SCOPING OPINION:

Proposed Cambridge Waste Water Treatment Plant Relocation

Case Reference: WW010003

November 2021

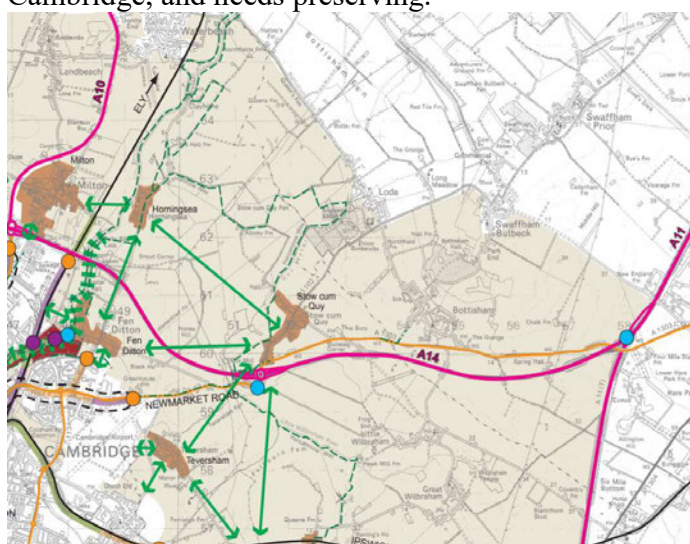
We object to AW's suggestion that a 22-hectare sewage works, lit at night, with several tanks up to 26 m high could be constructed above ground without it dominating the south-western gateway to the Vision and thereby completely destroying it. The tallest structures would rise above the trees and be visible for a considerable distance.

CPRE suggest that this area experiences an up lighting at night of only 1 to 2 nanowatts/cm². One of our residents was able to photograph a wonderful tranquil

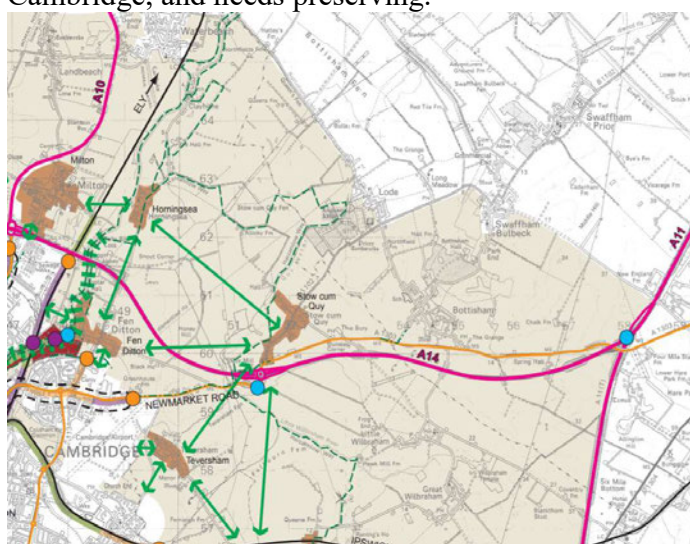
We object to AW's suggestion that a 22-hectare sewage works, lit at night, with several tanks up to 26 m high could be constructed above ground without it dominating the south-western gateway to the Vision and thereby completely destroying it. The tallest structures would rise above the trees and be visible for a considerable distance.

CPRE suggest that this area experiences an up lighting at night of only 1 to 2 nanowatts/cm². One of our residents was able to photograph a wonderful tranquil
